PART CHANGE NOTICE Document No. 195003 Date 23 Oct. 2013 CIRCUIT DESIGN, INC. Approved by Checked by Prepared by Model name CDP-TX-02E-R, EP-R, F-R, FP-R 434MHz Model No. U044B01, 03 Date 23 Oct. 2013 CIRCUIT DESIGN, INC.

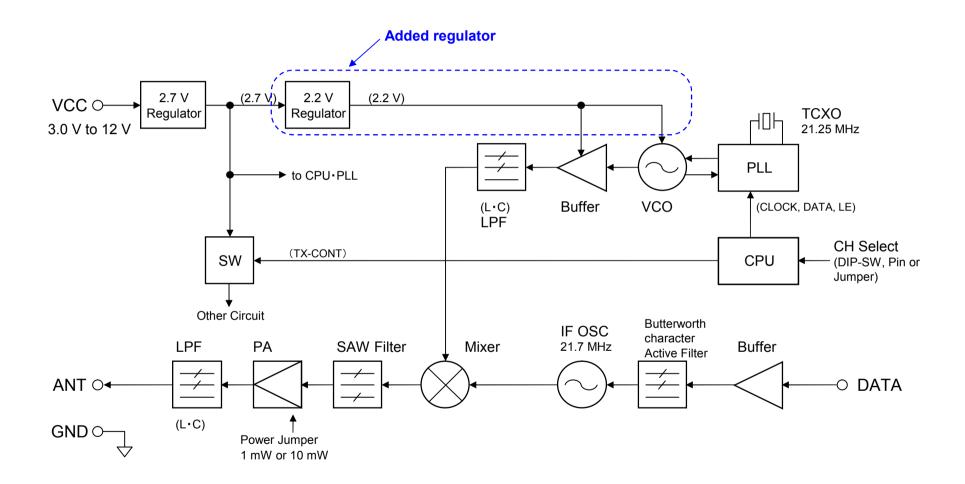
A regulator for the internal VCO was added (See attached block diagram).

In order to increase a margin of the power-off transient characteristics against the EN standard limit.

The VCO and the buffer operate at 2.2 V and other internal circuit operates at 2.7V.
